Amendments to the Drawings:

REMARKS

FIG.9 (a)
PRIOR ART

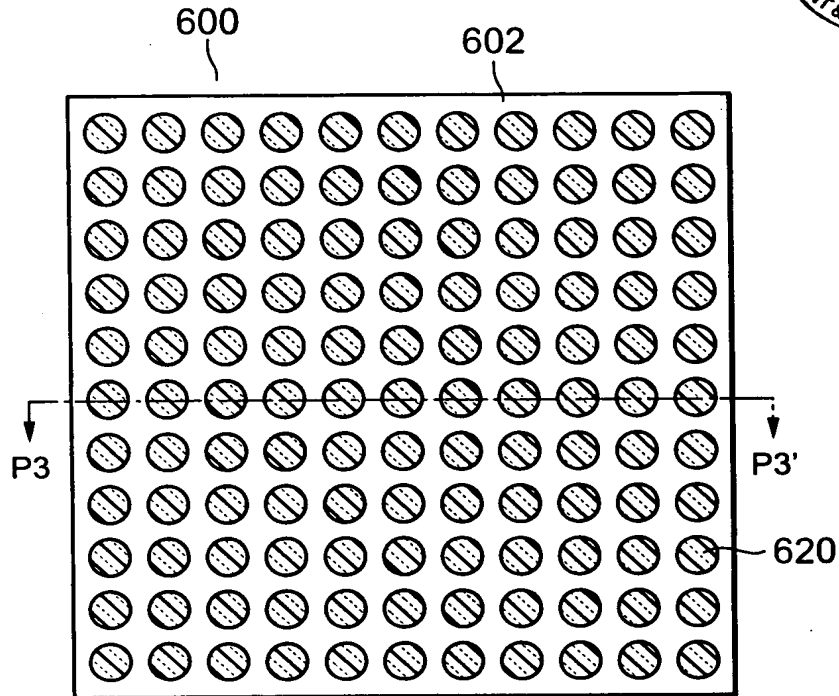
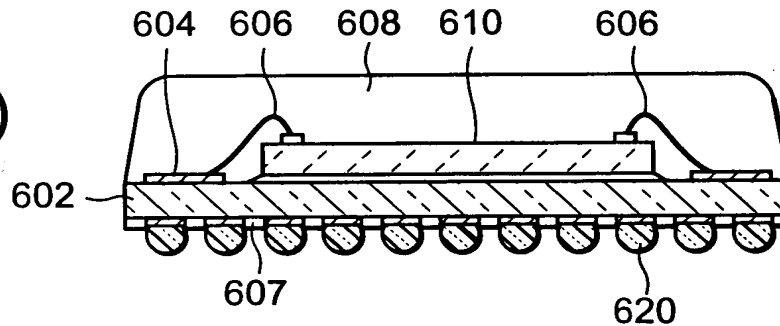
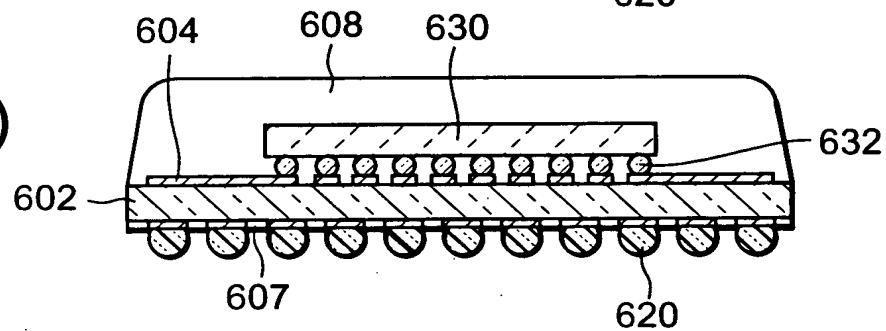
FIGS. 9a-9c have been labeled "Prior Art". Appended to this amendment is an annotated copy of the previous drawing sheet which has been marked to show changes presented in the replacement sheet of the drawing for FIGS. 9a-9c.

In the specification, paragraphs have been amended on pages 11-12. Figs. 9a-9c have been amended to be labeled as "PRIOR ART" as requested in the Examiner's Amendment. No claims are amended.
